4 May 2016

DEXUS QUARRYWEST PROJECT (SSD 6801) – SECTION 96 MODIFICATION (MOD 1) – STATEMENT OF ENVIRONMENTAL EFFECTS

Figure 5: QuarryWEST Precinct A (and C & D) Site Plan – As Proposed

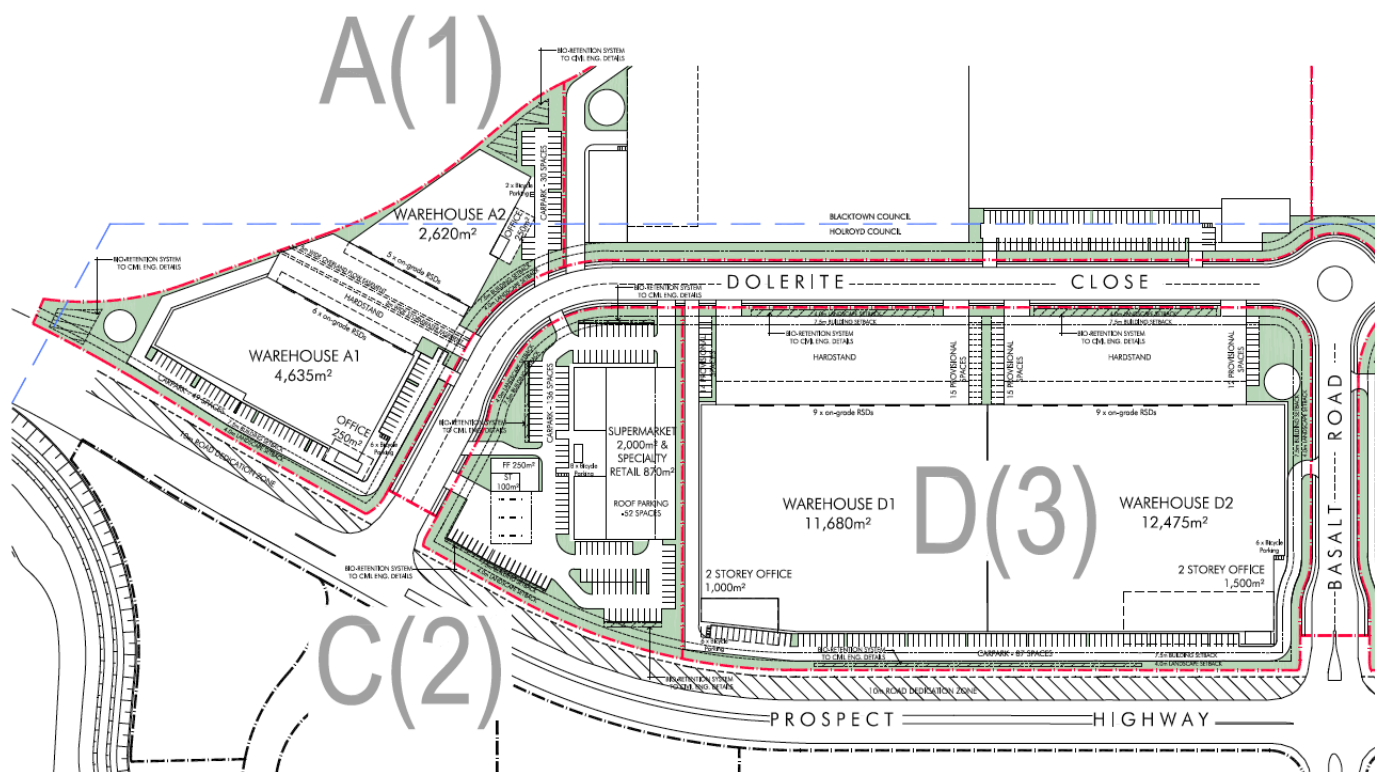
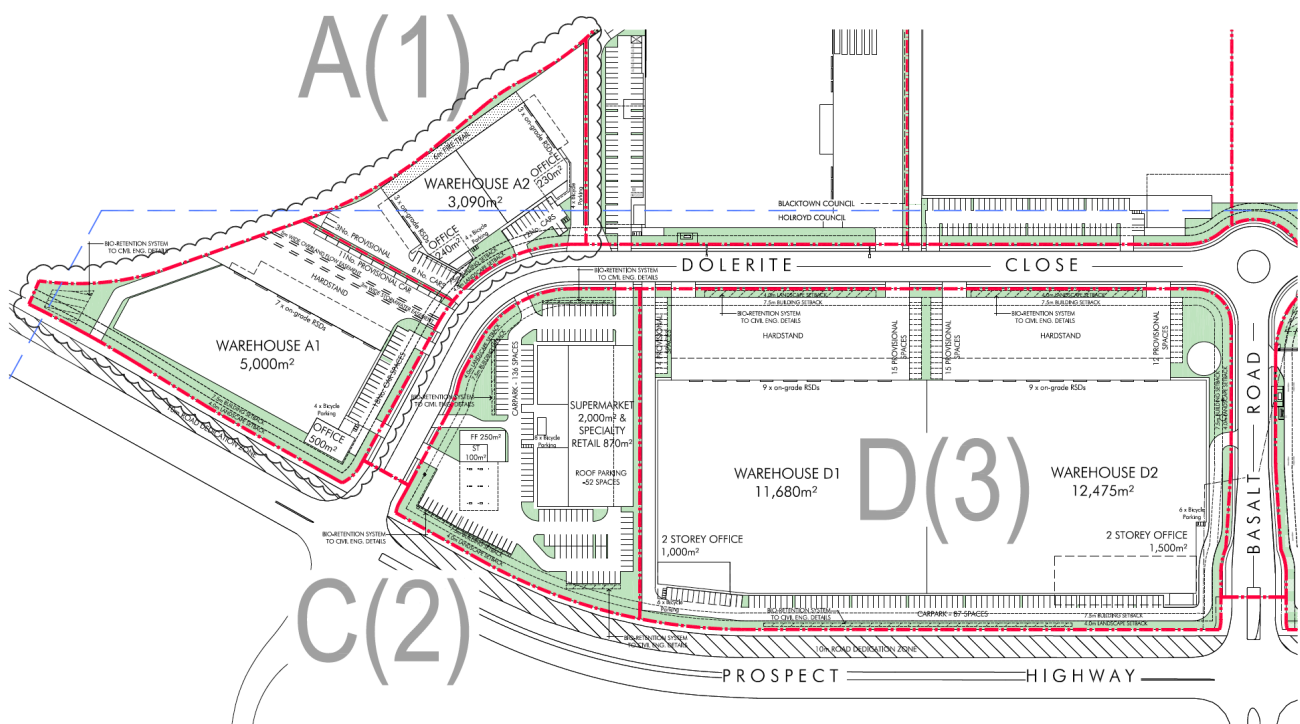
- ***Precinct A:***
 - a small increase in the area of the precinct with an adjustment to the internal boundary with Precinct B;
 - a minor increase in the area of Warehouse A1, and minor alteration to the layout of the facility;

- a minor increase in the area of Warehouse A2, and alteration to the layout of the facility, including provision for the warehouse to be split into 2 warehouse units; and

- addition of an internal lot boundary between Warehouses A1 and A2;
- ***Precinct B:***
 - a small decrease in the area of the precinct with an adjustment to the internal boundary with Precinct A;

Figure 6: QuarryWEST Precinct B Site Plan – As Proposed

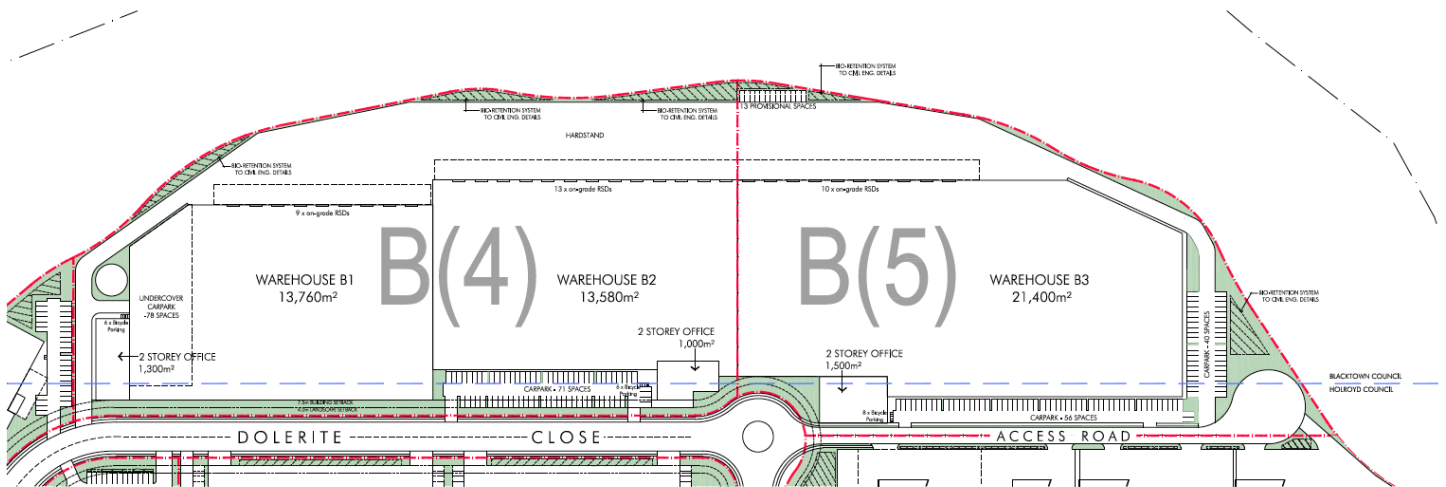
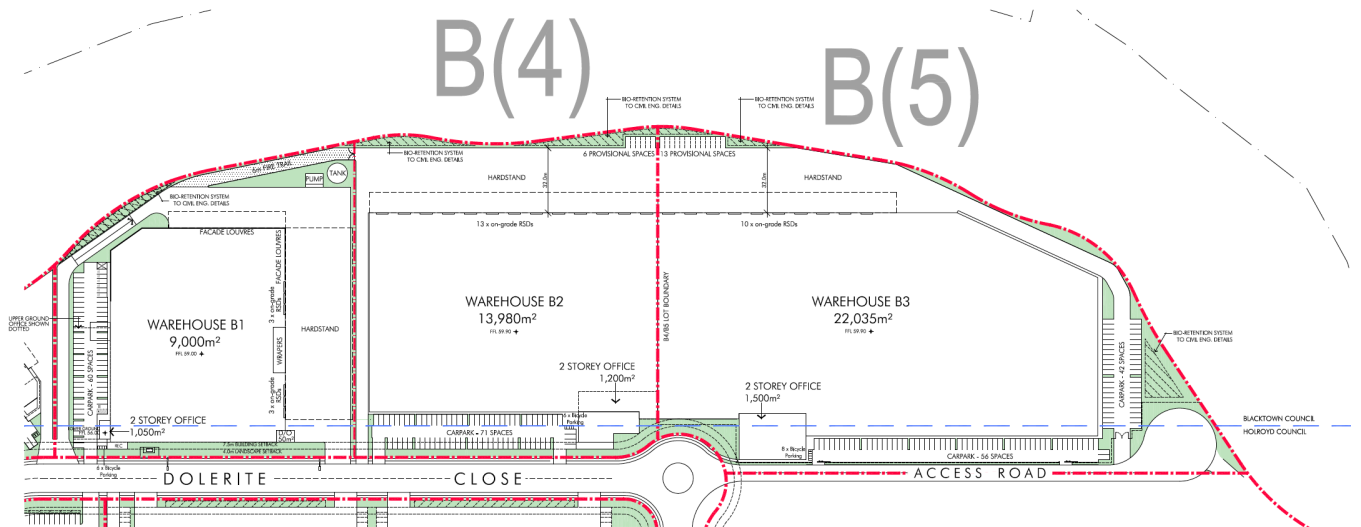
- a decrease in the area of Warehouse B1, and alterations to the layout of the facility, including detaching the facility from Warehouses B2 and B3;
 - a minor increase in the areas of Warehouses B2 and B3, and minor alteration to the layout of the facilities; and

- addition of an internal lot boundary between Warehouses B1 and B2; and
- ***Precinct E:***
 - addition of an internal mezzanine Level 1 office in Warehouse E1 (the Toshiba Facility).
